**VILLAGE OF GERMANTOWN
N112 W17001 MEQUON ROAD
GERMANTOWN, WI 53022**

MEETING: REGULAR MEETING OF THE VILLAGE BOARD

DATE AND TIME: MONDAY, AUGUST 19, 2019 7:00 p.m.

PLANNED DEVELOPMENT DISTRICT (PDD) REZONING, CERTIFIED SURVEY MAP (CSM) & SITE PLAN APPLICATIONS

CERTIFIED SURVEY MAP NO.

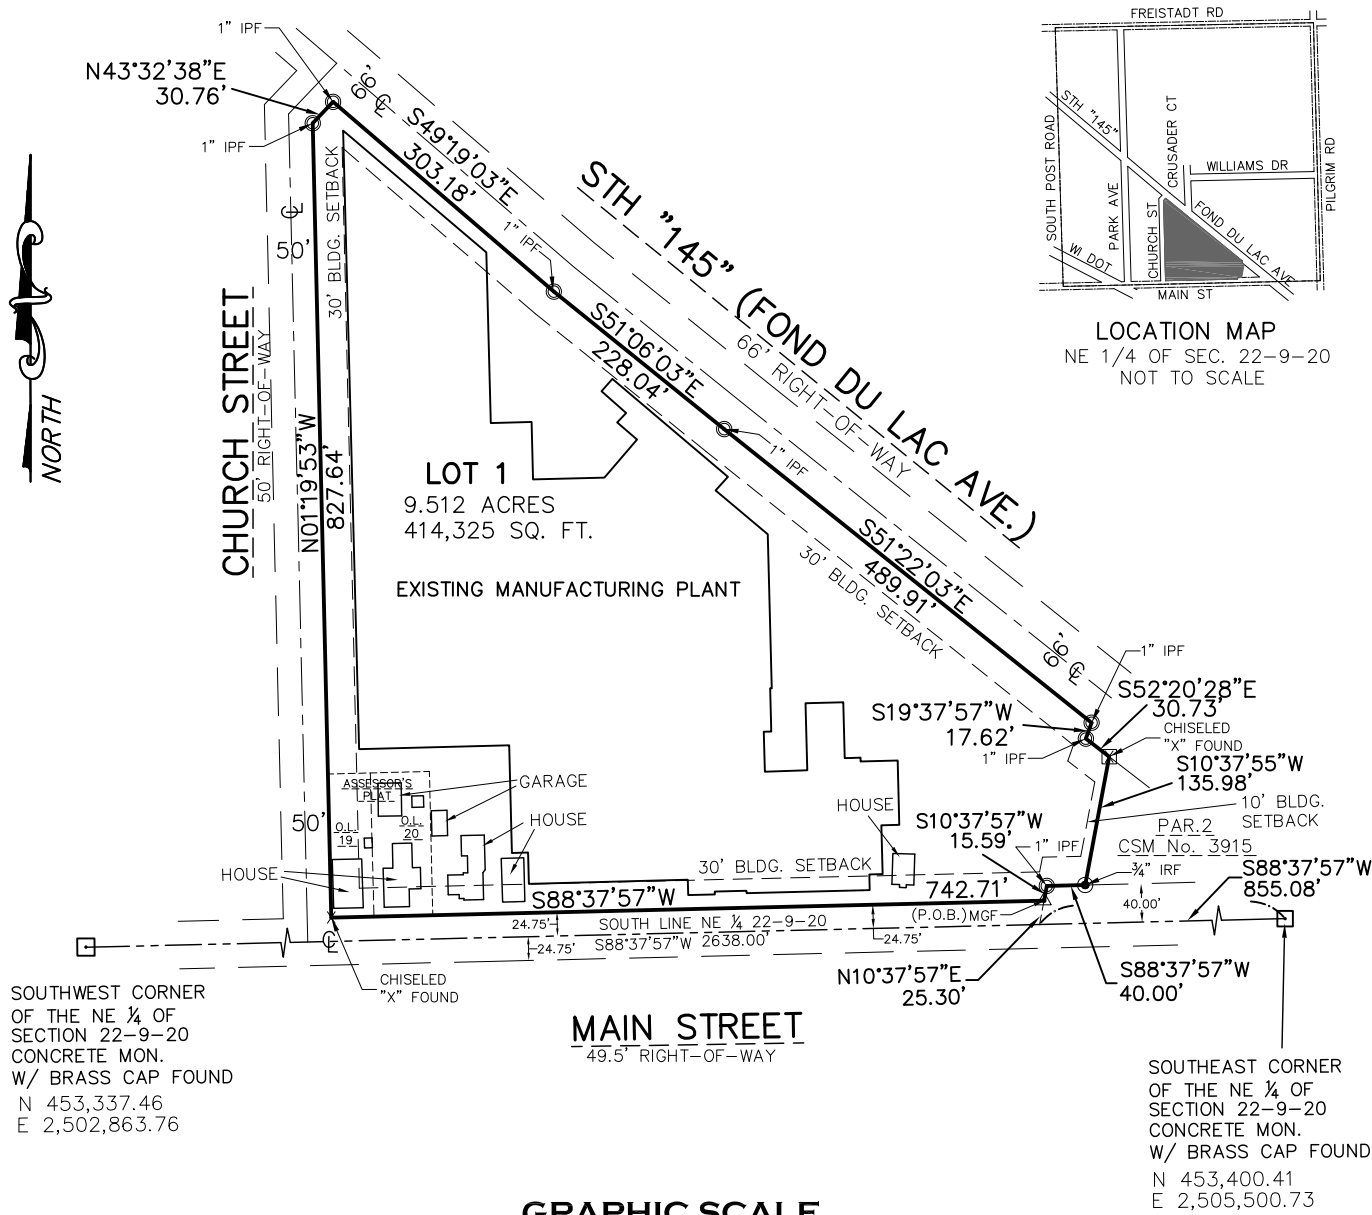
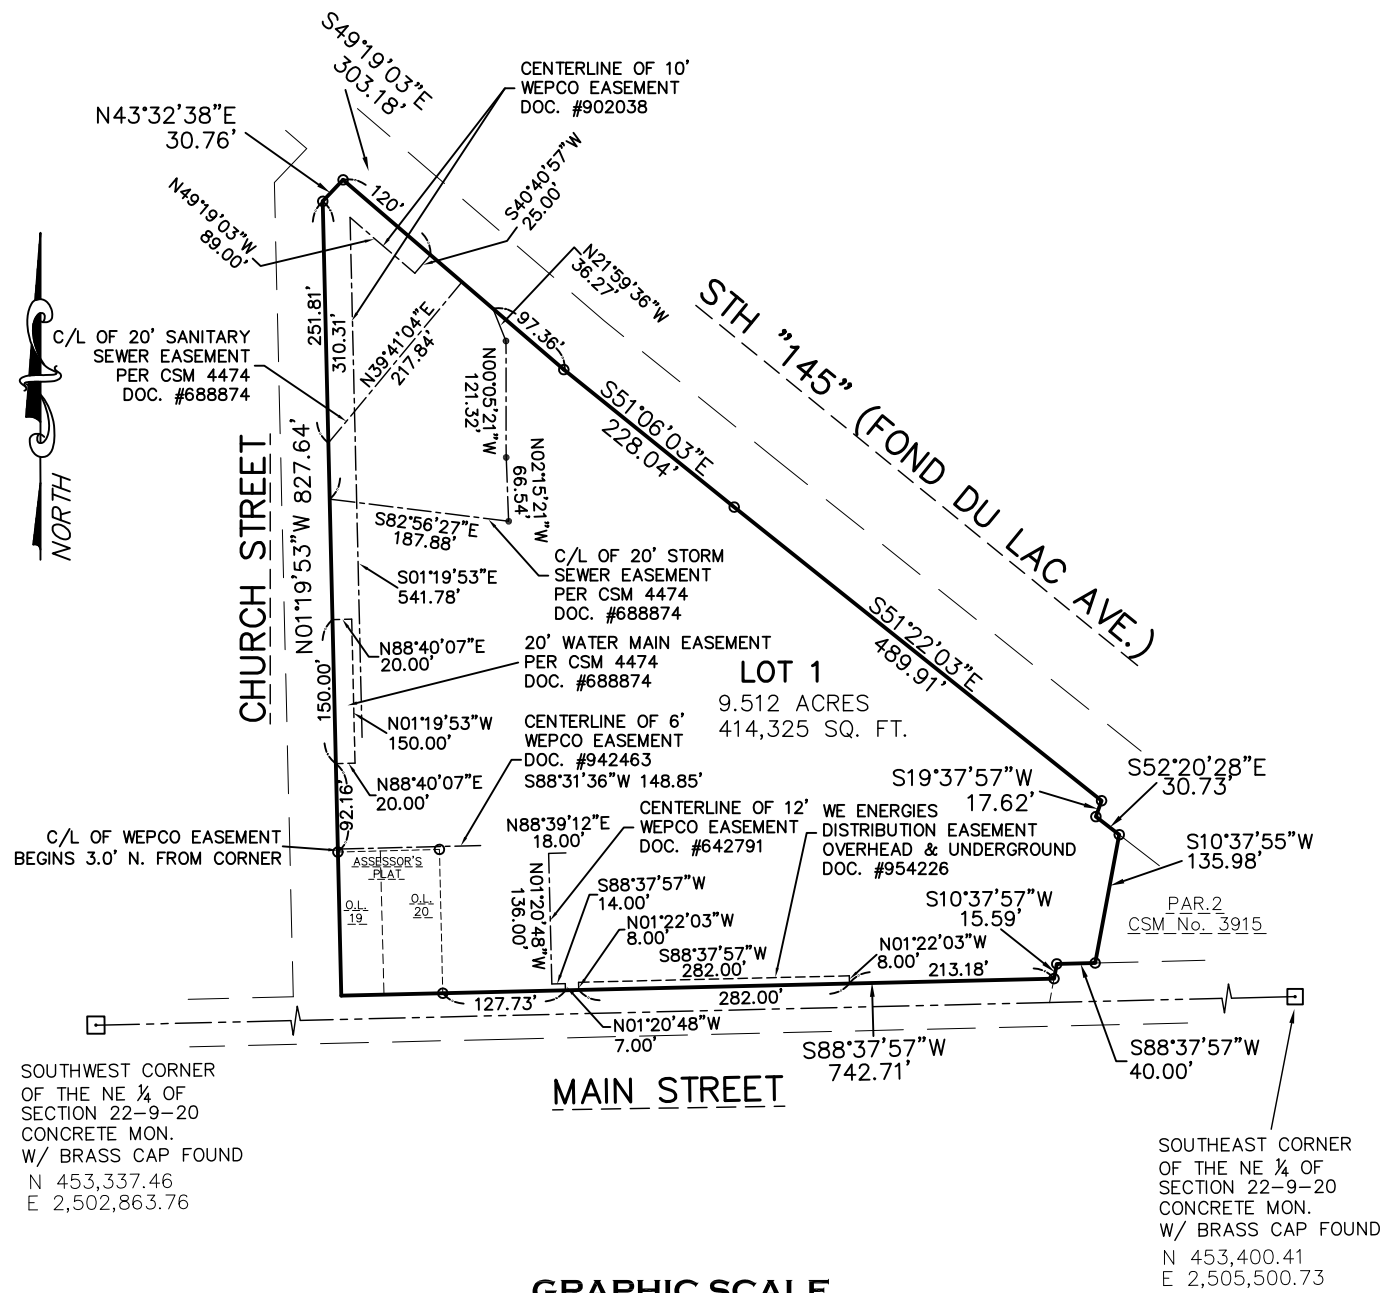
1. A 3"x3" square as measured from the top and right edge of the paper is required by the Washington County Register of Deeds for recording information on the first sheet of this CSM document.
2. A notary signature block is required for all signatures including Village plan commission and Board approval certificates. Please add the notary signature blocks as needed.
3. Incorrect Village Clerk's name on the Village Board Certificate. The current clerk's name is Deanna Braunschweig, WCMC/CMC
4. The Section Number in the Village Board Certificate is incorrect.

C1.0
SHEET 1 OF 2

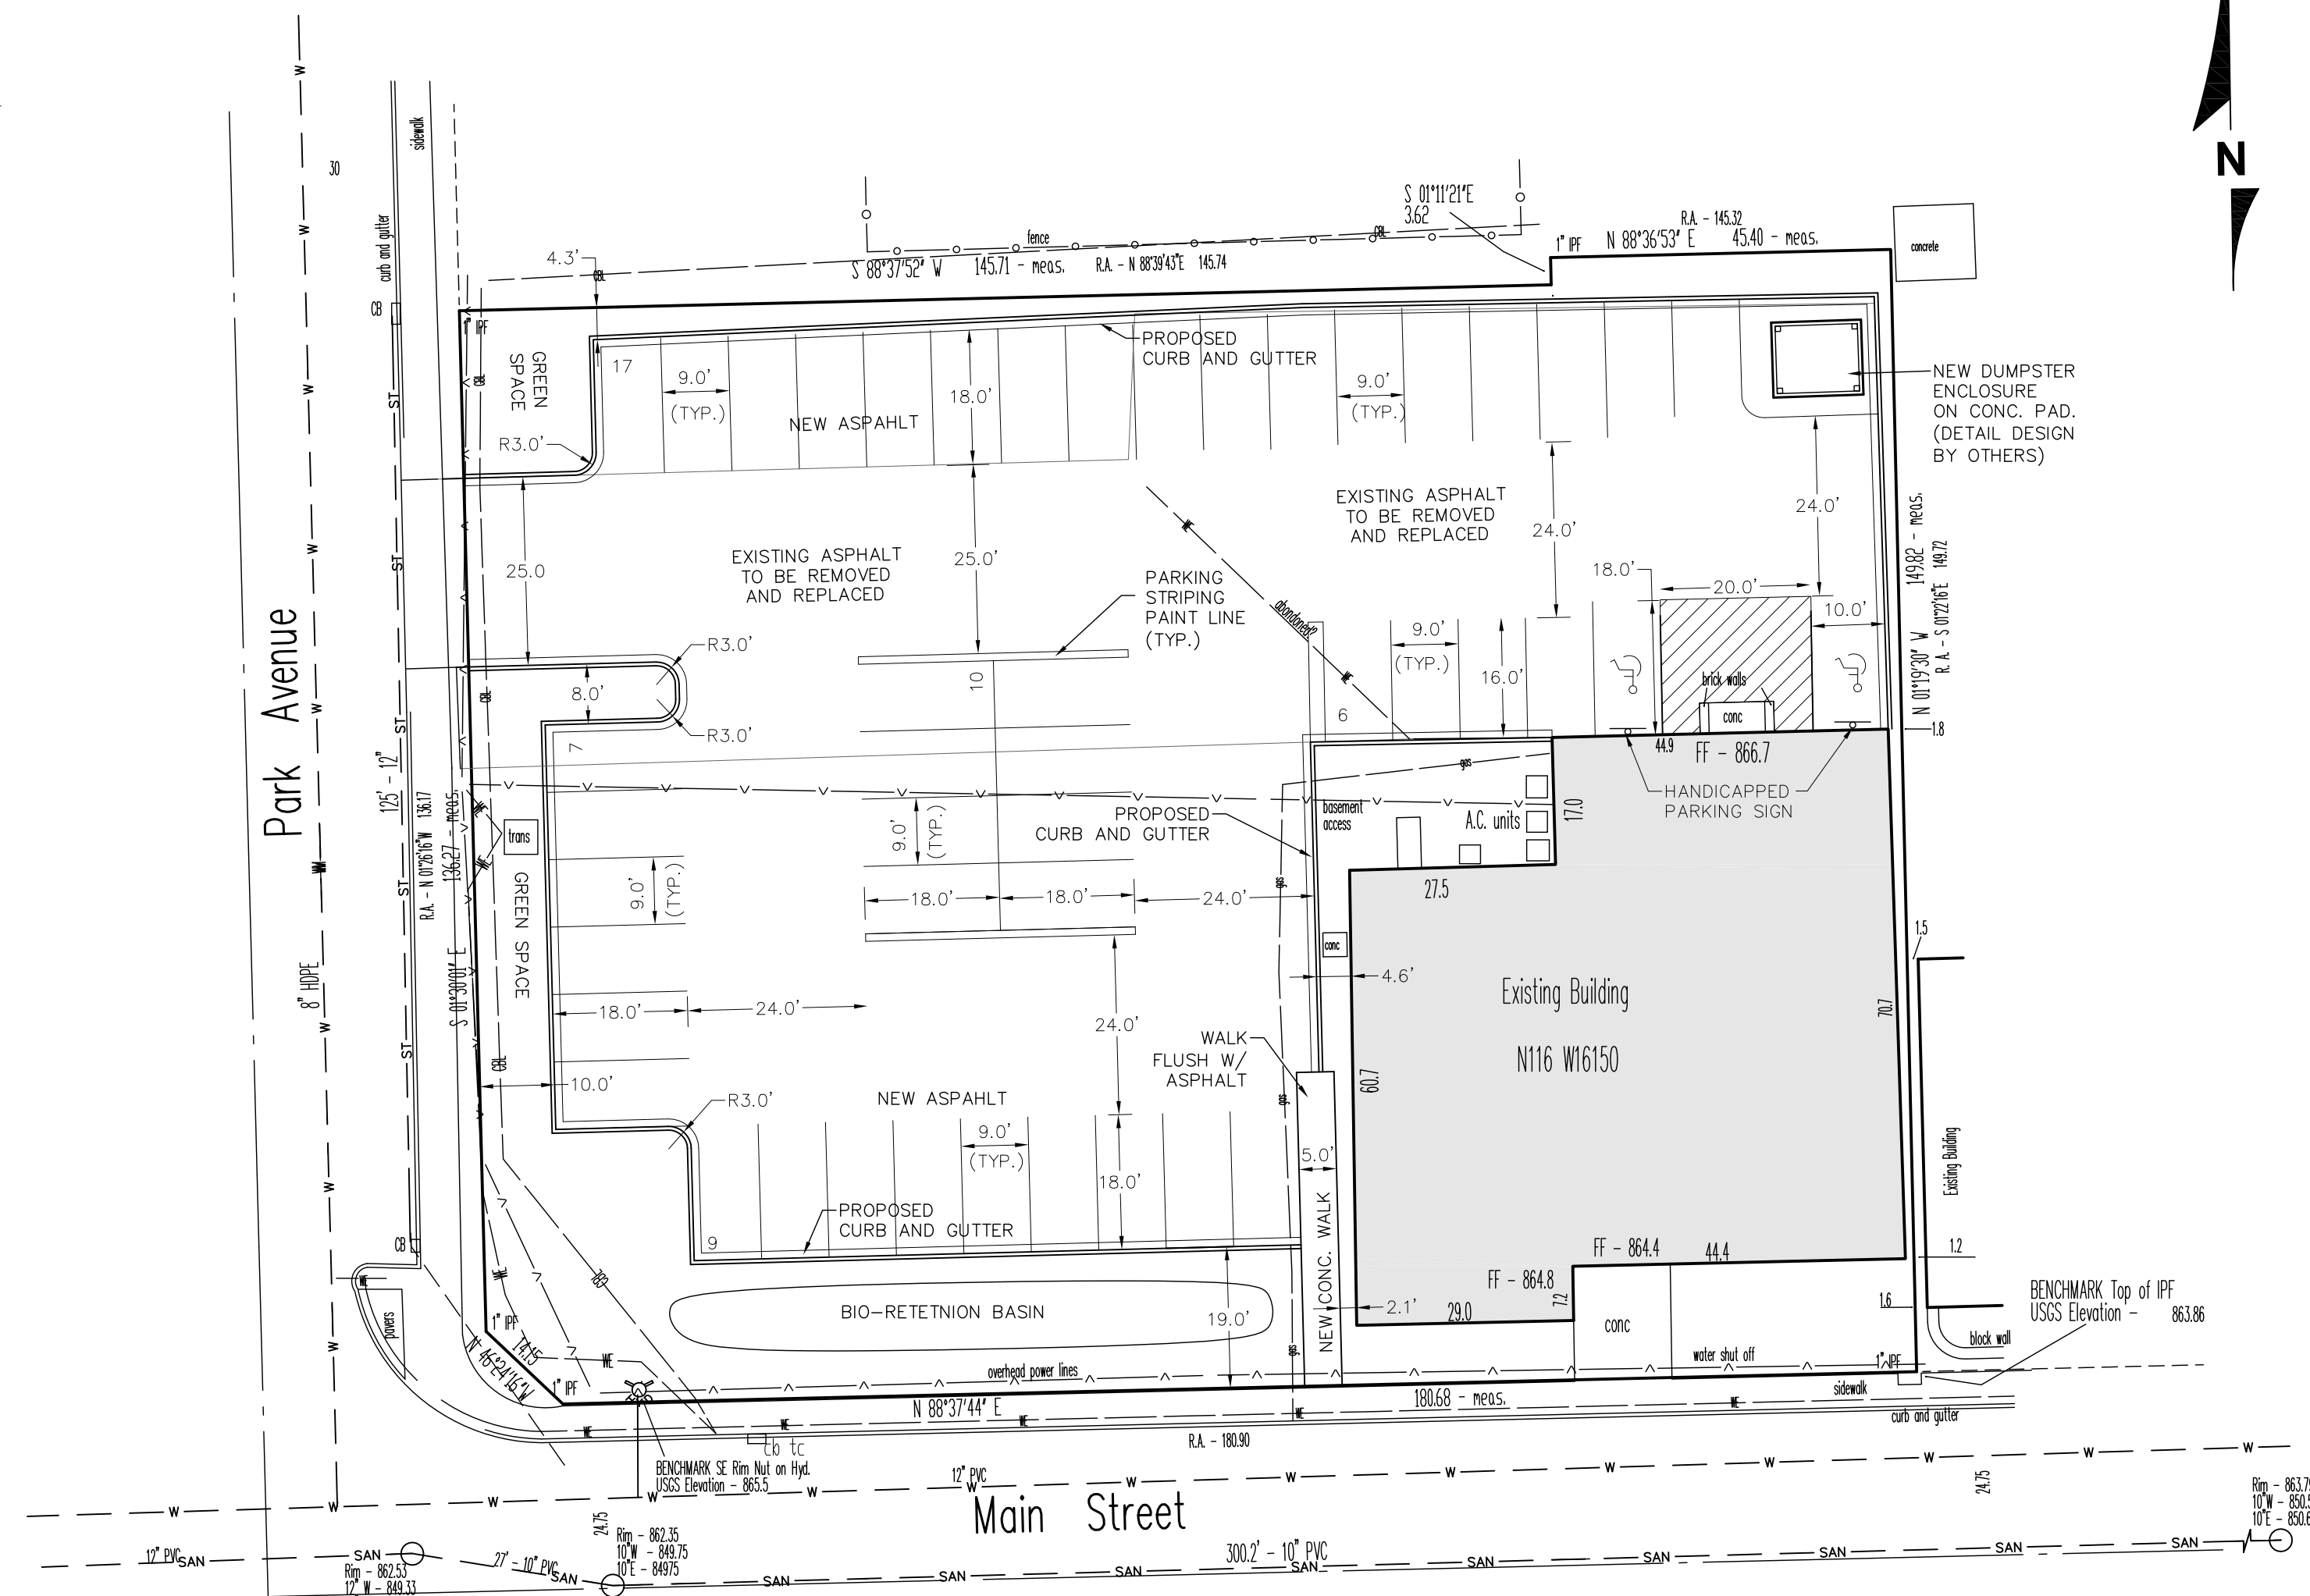
C1.0 Site Plan

1. Is the proposed parking lot entrance off main street intended to be for two way traffic? Please dimension width of existing drive and add pavement arrows and signage to indicate traffic directions.
2. Proposed parking lot shall meet the minimum ADA parking space requirements. Either add ADA parking spaces or show where an adequate number of spaces are provided elsewhere on-site.
3. Clearly denotes areas of proposed asphalt pavement and concrete.
4. Plan is difficult to read and determine what is existing to remain and what is proposed. Clearly denote limits of existing to remain and proposed improvements.
5. Proposed driveway approach from Church Street shall match Village standards. Add Village standard detail to the plan set.
6. Provide a warning sign for the rail spur as required by the MUTCD
